EQUIPMENT TYPE: KWS-1 TRANSMITTER

SUBJECT: PREVENT OFF FREQUENCY OSCILLATION APPEARING ON THE OUTPUT

EQUIPMENT TYPE KWS-1 **BULLETIN NO.** 2A **DATE** 1-25-57
Page 1 of 4

SUBJECT: A. USE OF CRYSTAL MICROPHONE WITH KWS-1
 B. PREVENT ARCING OF CONTACTS ON VOX RELAY
 C. HEAT REDUCING TUBE SHIELDS

BEFORE MODIFICATION

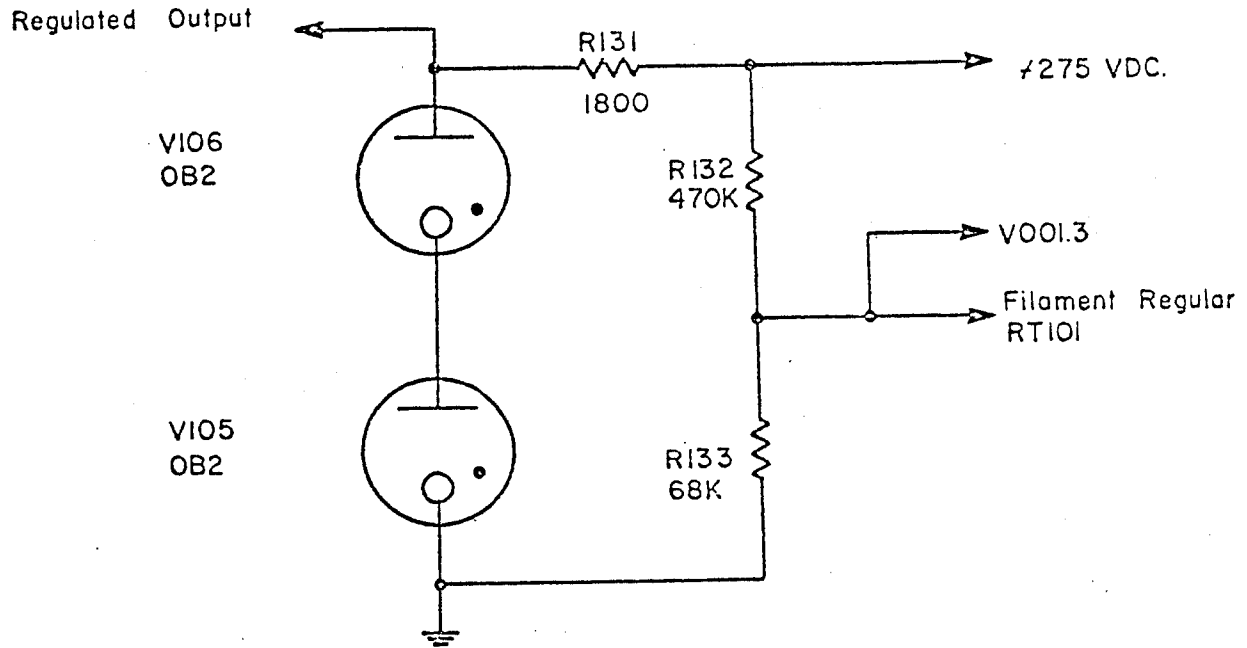
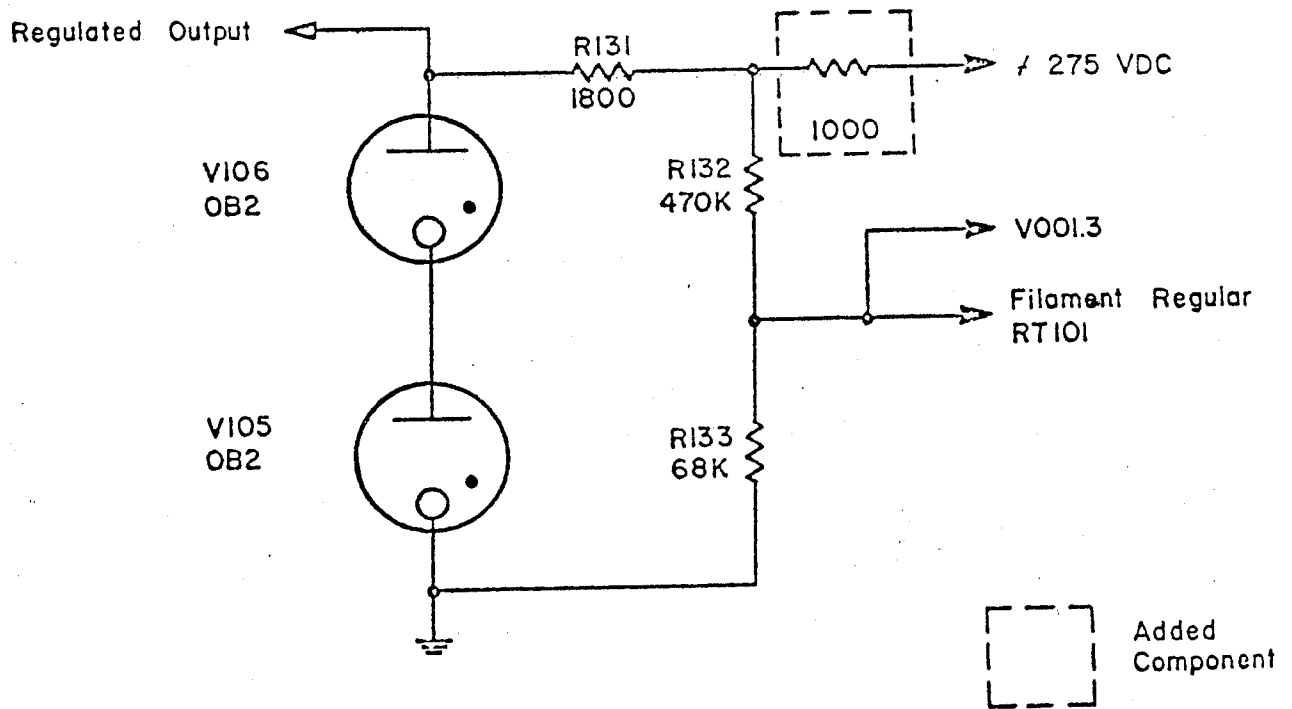
It has been determined that the current through the voltage regulator tubes V105 and V106 is exceeding the tube ratings and has caused an oscillation to appear on the output approximately 15KCs removed from the operating frequency. This condition can be eliminated by the insertion of a 1000 ohm resistor in series with the input of the VR tubes which reduces the current drain.

In production units with serial number 372 and above this modification is accomplished by changing the value of R131 from 1800 ohm to 2700 ohms. The following procedure is recommended for field modification on serial numbers 371 and below.

1. Remove bottom cover from Exciter/Power Amplifier.
2. Remove the white lead with red tracer, coming from the oscillator housing assembly, from the B / insulated terminal beside the VOX relay.
3. Install an insulated terminal, CPN 306 0234 00, on the RF Chassis using the screw which holds the solder lugs to which the yellow coax shields are tied.
4. Connect a 1000 ohm 2 watt resistor, CPN 745 5652 00, between the B / terminal and the newly installed terminal.
5. Connect the white lead with read tracer removed in step 2 above to the newly installed terminal.
6. Replace bottom cover.

FIGURE 2

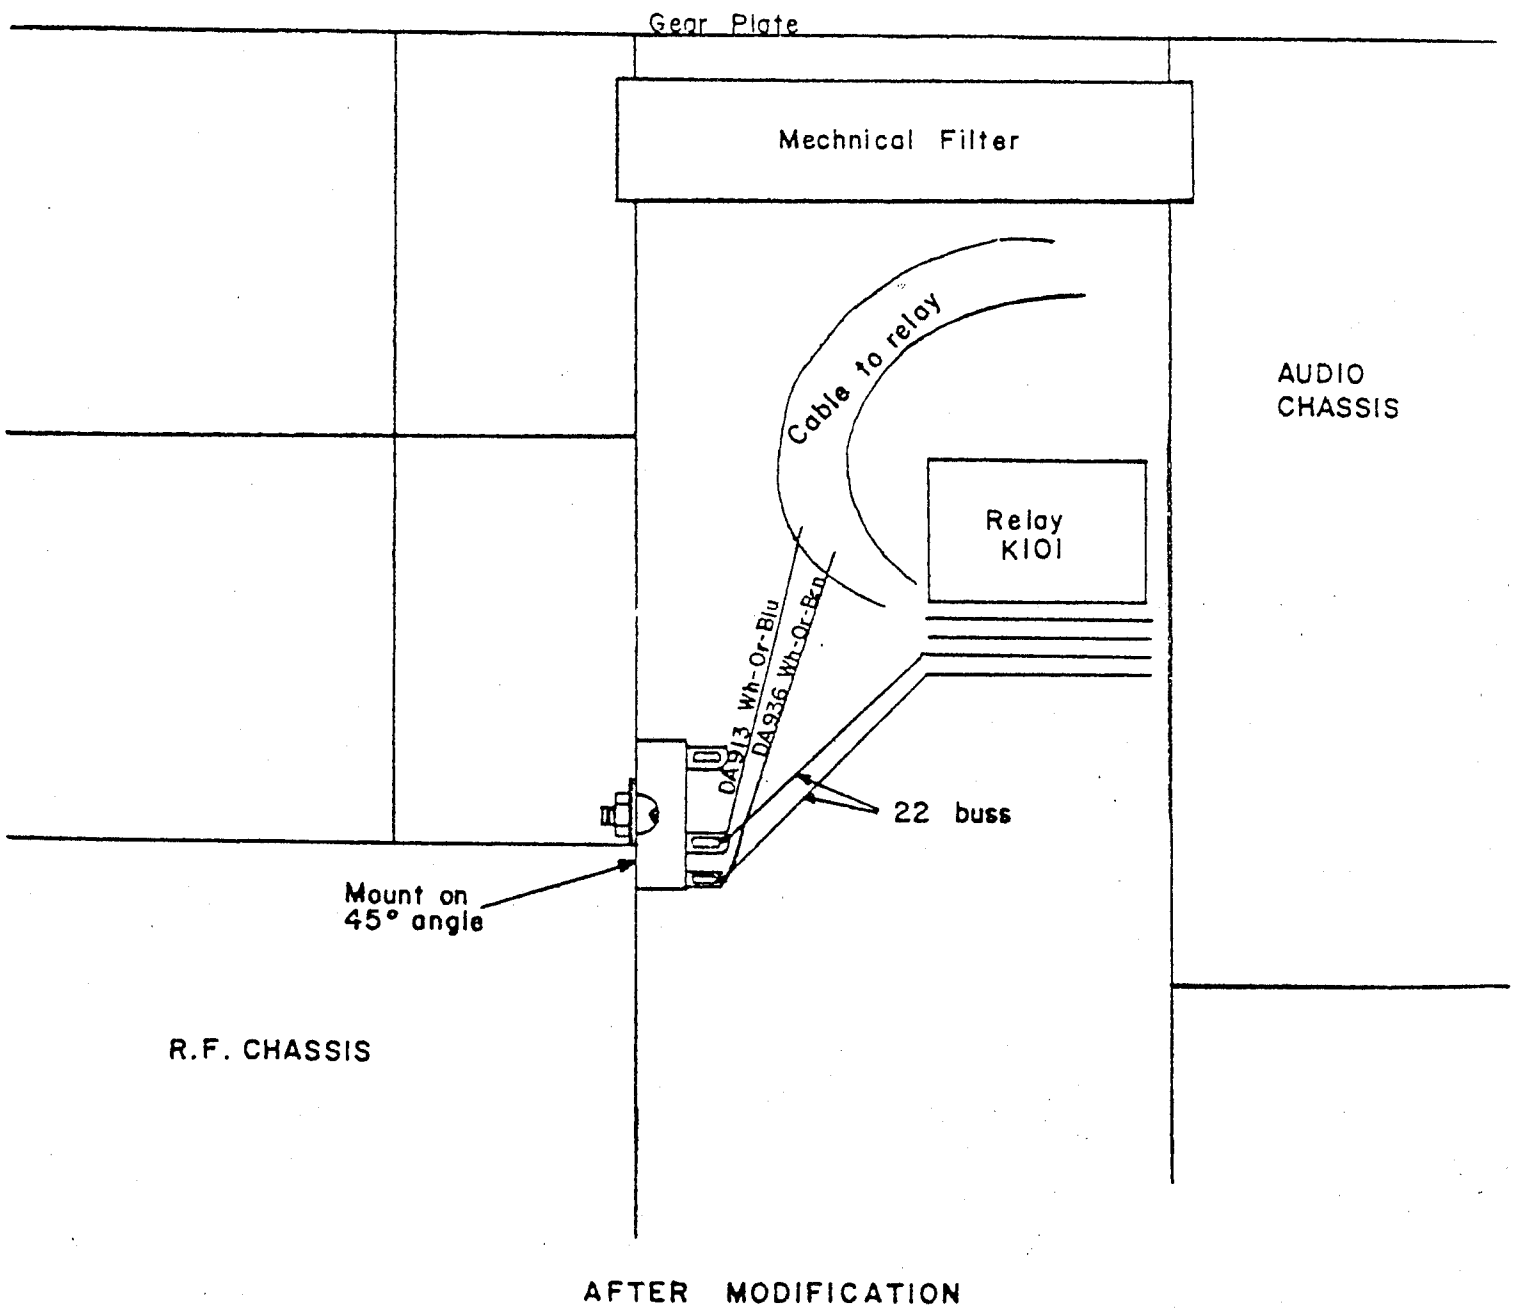
It has been discovered that some arcing is taking place at contacts 4 and 5 on the voice operate relay, K101, in the KWS-1. To prevent this arcing and increase the life of the relay contacts an arc suppression filter has been incorporated in production of the exciter effective with serial number 695. It is recommended that this filter be installed on all units below the above serial number and may be accomplished as described below.

1. Mount resistor R246, 100 ohm 1 watt \pm 10% (CPN 745 3310 00) and capacitor C315, .01 mfd 500V (CPN 913 1188 00) on tie point (CPN 306 2230 00) as shown in Figure 1. Do not solder.
2. Mount above assembly under existing screw which fastens shield to RF chassis as shown in Figure 2.
3. Remove DA936, white with orange and blue tracers, wire from terminal 5 of K101 and connect to tie point assembly as shown in Fig. 2.
4. Remove DA913, white with orange and brown tracers, wire from terminal 4 of K101 and connect to tie point assembly as shown in Fig. 2.
5. Connect terminals 4 and 5 of K101 to the tie points using #22 buss wire (CPN 421 2220 00) as shown in Figure 2. Solder all connections.
6. Replace bottom plate onto exciter.
